1st Further Information

**Proposed Temporary Place of Recreation, Sports or Culture (Hobby Farm) with Ancillary Eating Place and Associated Filling of Land for a Period of 5 Years in "Agriculture" ("AGR") Zone and Area shown as 'Road',
Various Lots in D.D. 17 and Adjoining Government Land, Ting Kok, Tai Po, New Territories**

(S.16 Planning Application No. A/NE-TK/843)

Response-to-Comment (RtC)

24 Seats Light Buses Swept Path Demonstration

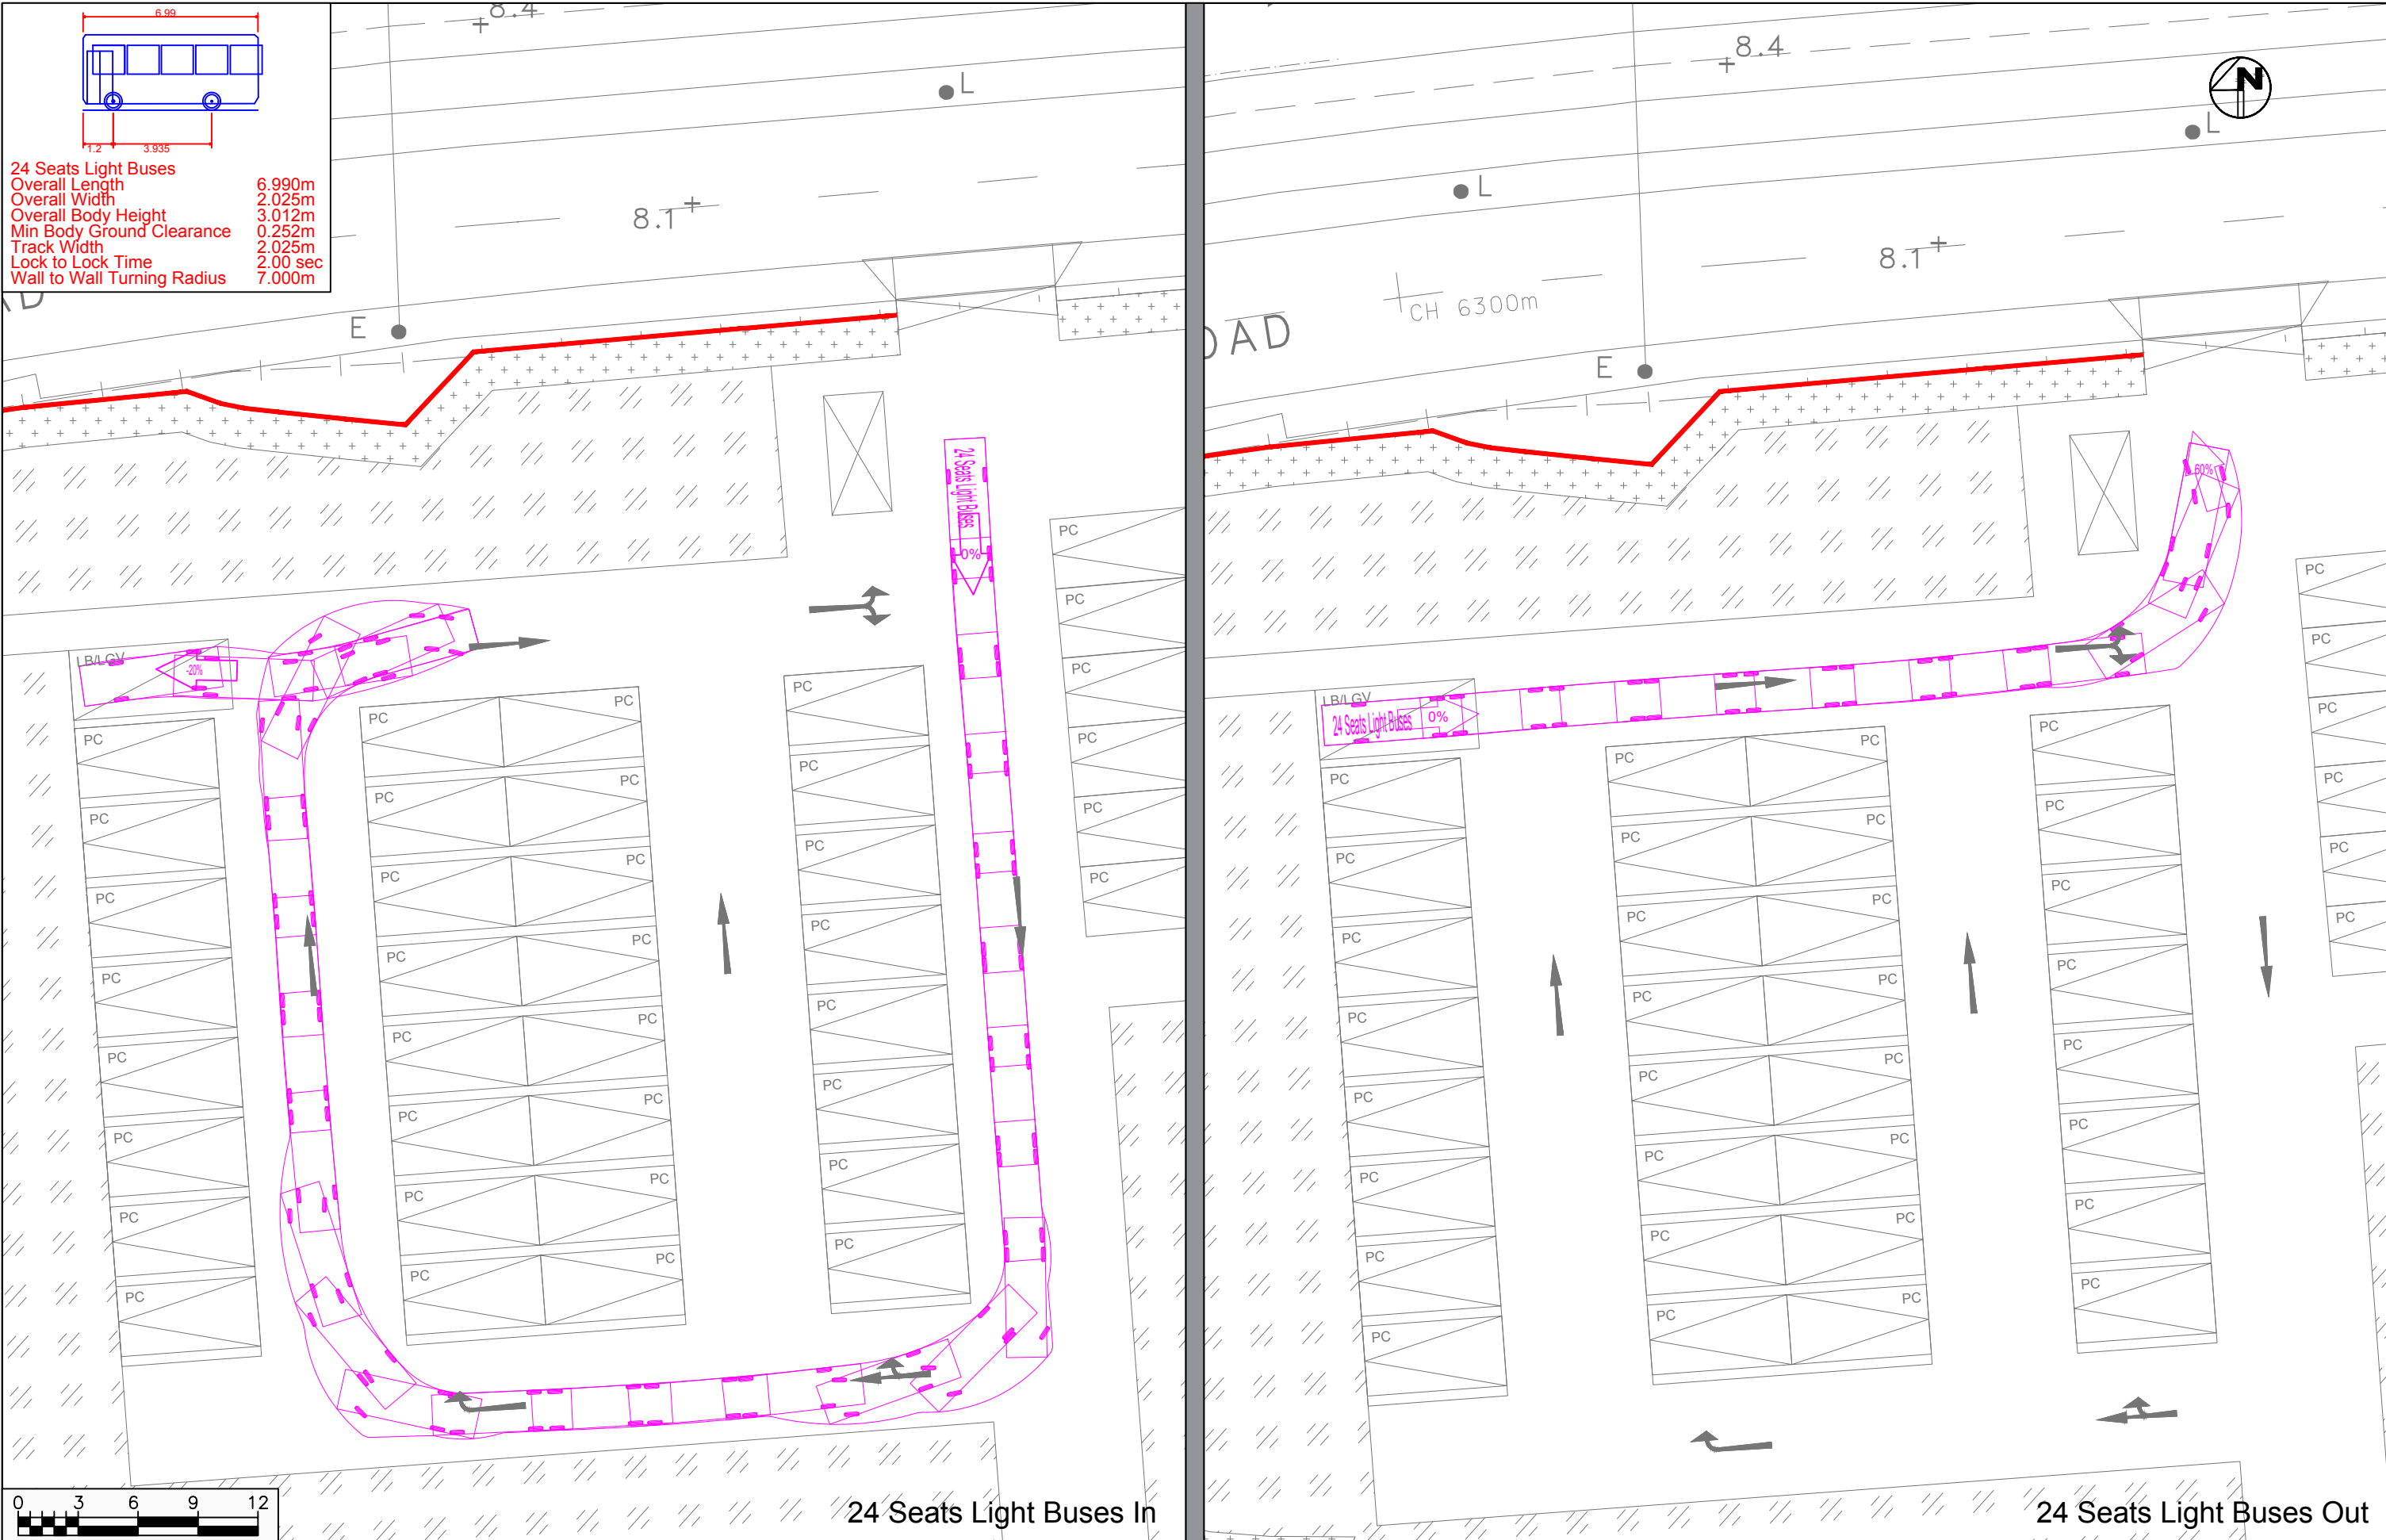
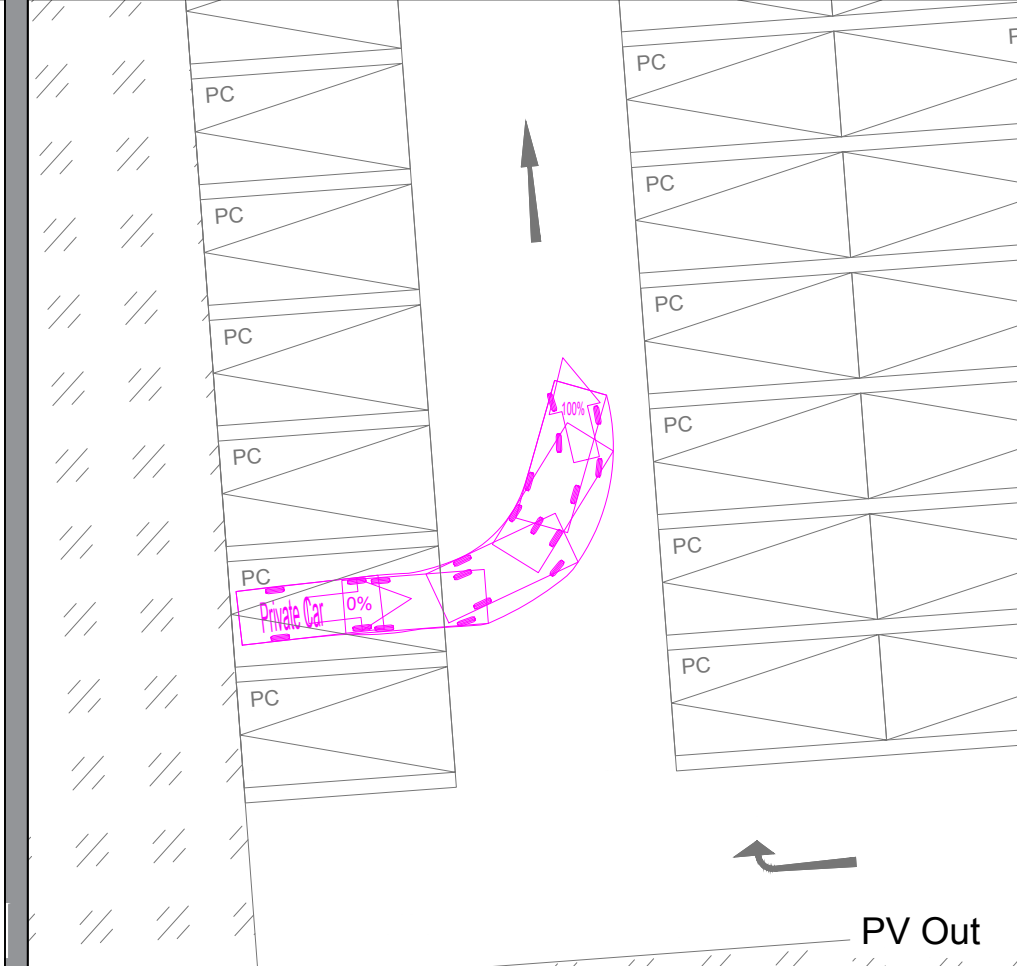
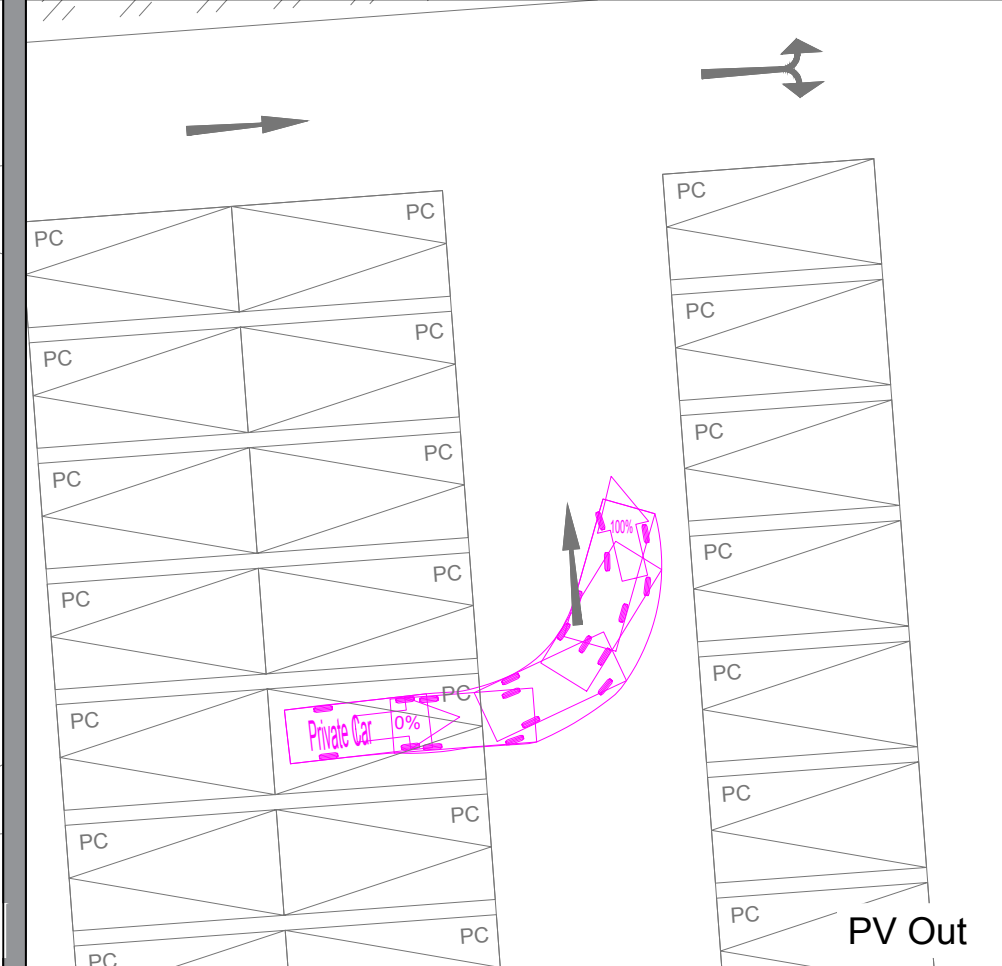
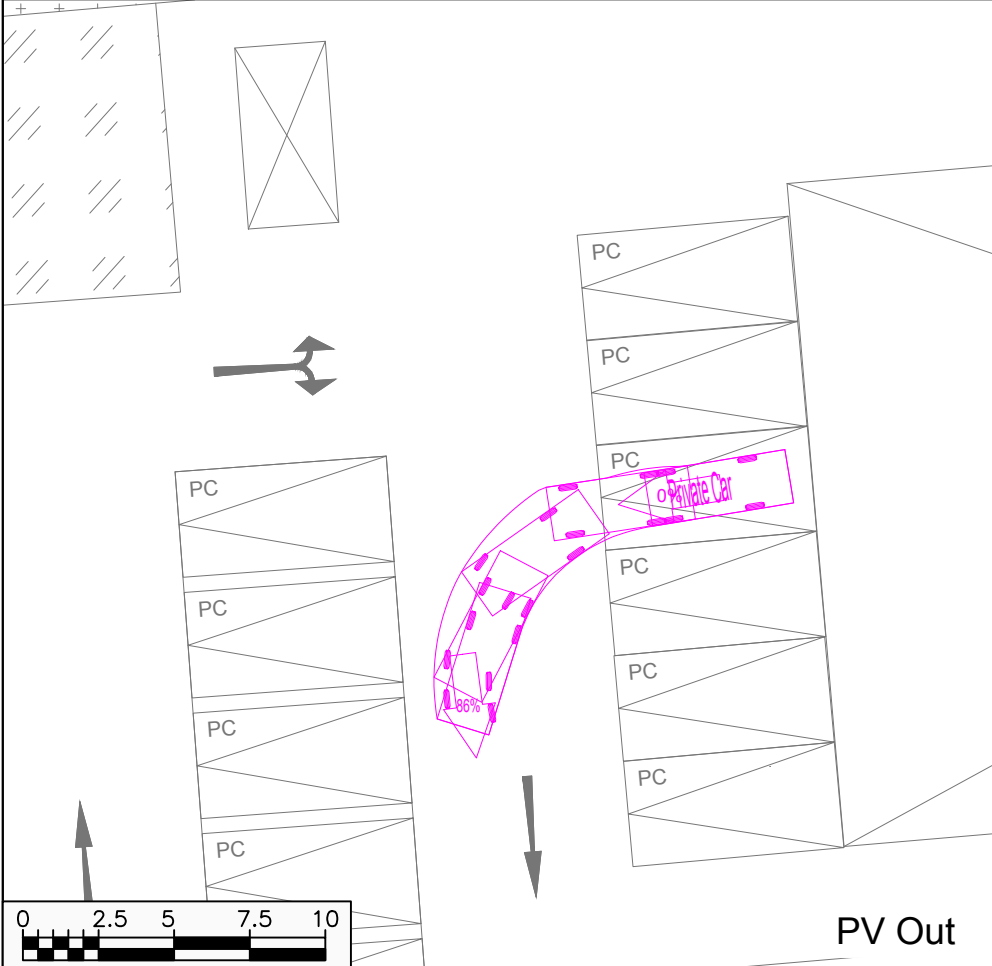
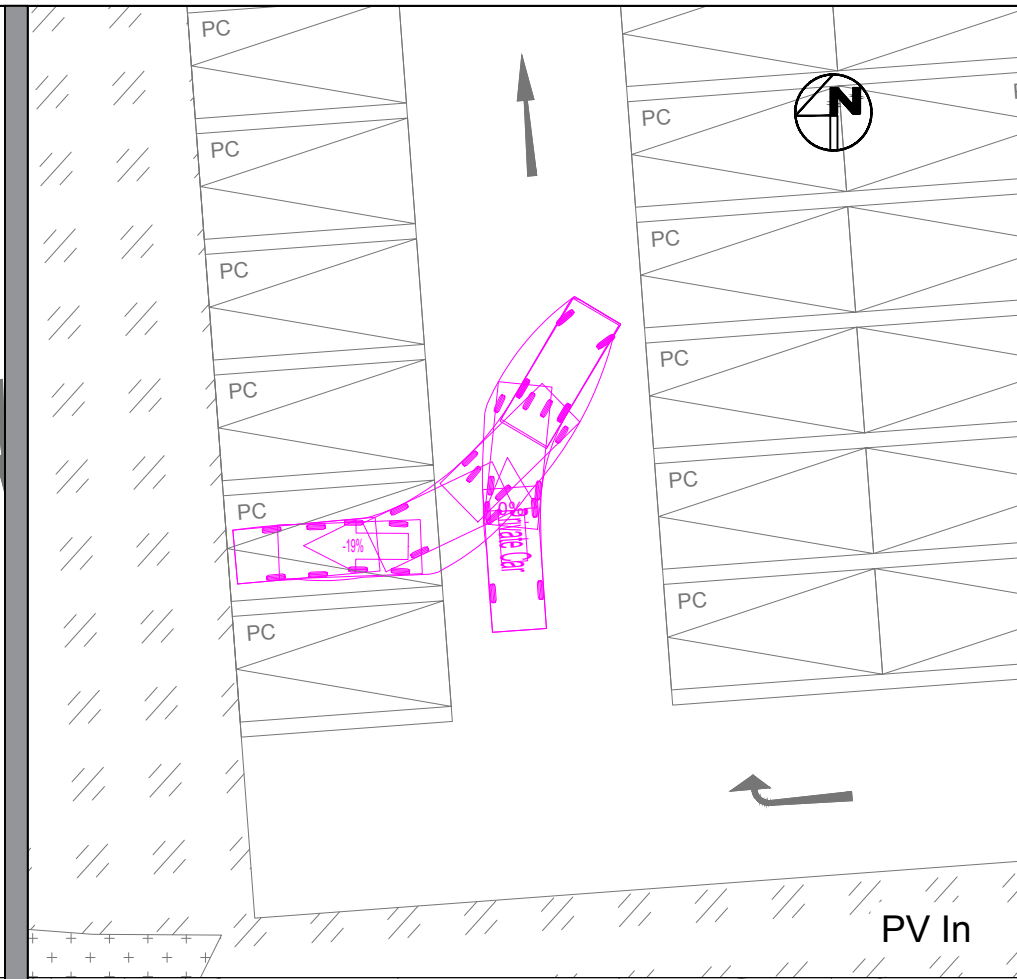
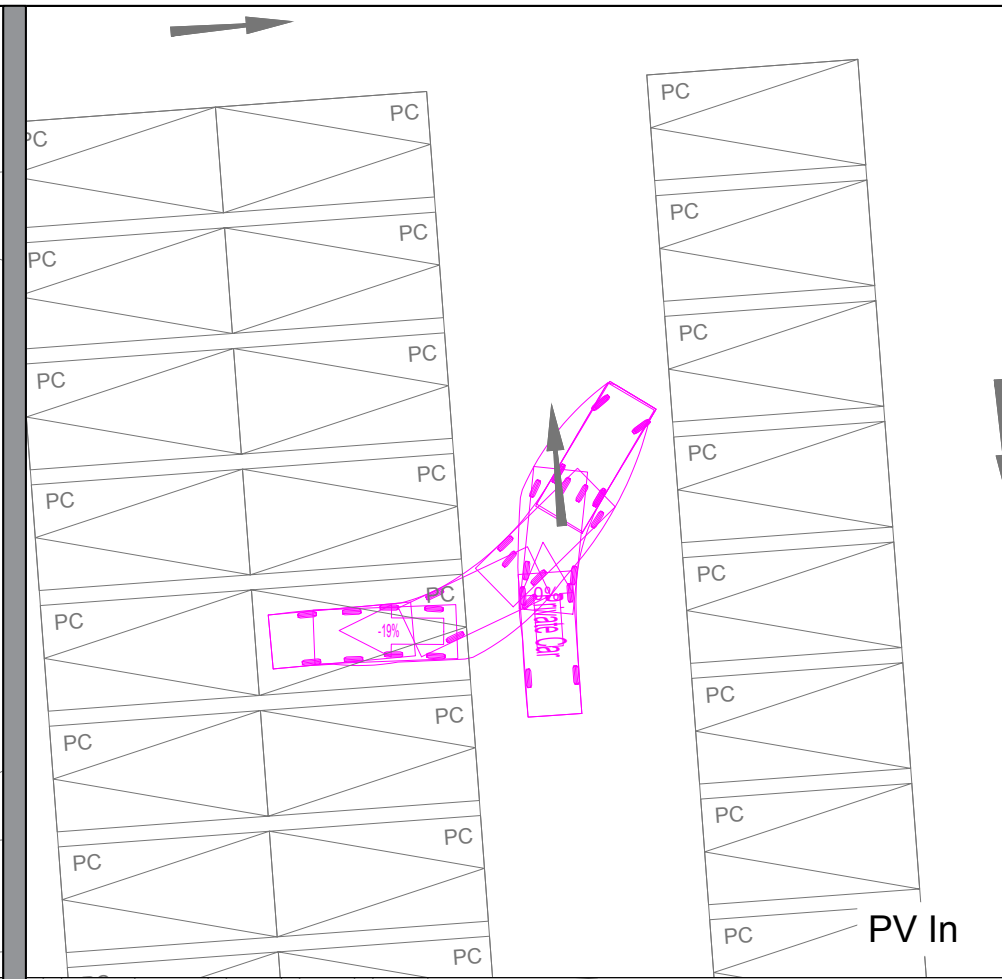
(e)	The applicant shall demonstrate the vehicles can be manoeuvred smoothly within the site without queuing on public road.	The swept path analyses are enclosed at Appendix A of Annex 3 . Sufficient space is provided for vehicles to manoeuvre smoothly within the Site to ensure that no vehicle will be allowed to queue back to or reverse onto/from the Site to public roads. Road markings are also proposed for clearer guidance within the Site.
